**STAFF REPORT:**  
**APPLICATION FOR COA**  
Bowling Green/ Warren County  
Historic Preservation Board  
1141 State Street  
Bowling Green, KY 42101

<b><u>DATE OF HEARING:</u></b>	February 22, 2018	<b><u>DOCKET NUMBER:</u></b>	2018-01-COA
<b><u>LOCATION:</u></b>	511 E. 10 <sup>th</sup> Avenue	<b><u>HISTORIC DISTRICT:</u></b>	Downtown Commercial
<b><u>PVA PARCEL NUMBER:</u></b>	039A-06-005	<b><u>CURRENT ZONING:</u></b>	CB (Central Business)
<b><u>HISTORIC RESOURCE SURVEY NUMBER:</u></b>	WA-B-0047 (aka Jessee Building)

## PROPOSED SCOPE OF WORK

## STAFF ANALYSIS

511 rear

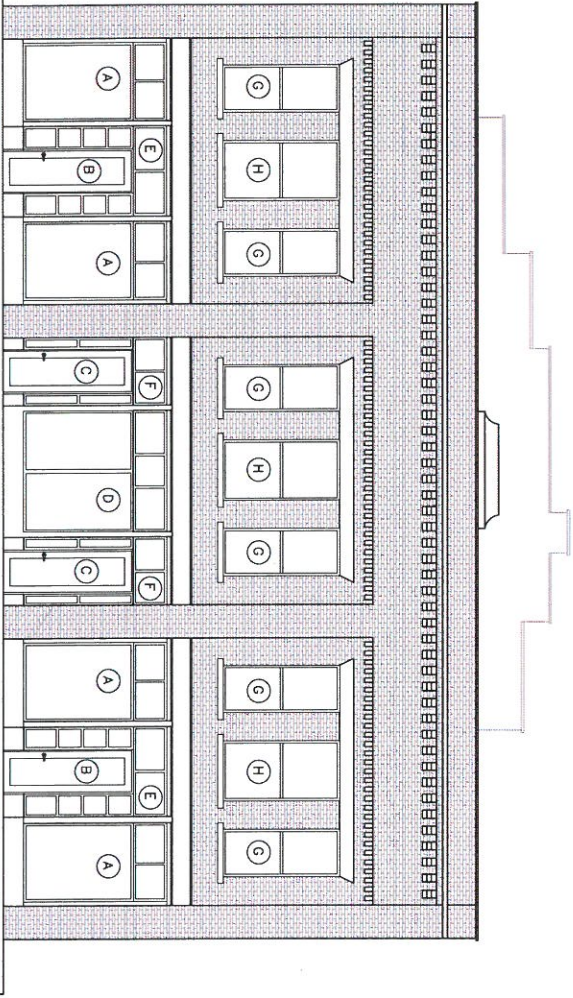
- ❖ The addition of horizontally sliding glass windows on the rear of the building may not be appropriate for the structure or the Downtown Commercial Historic District.
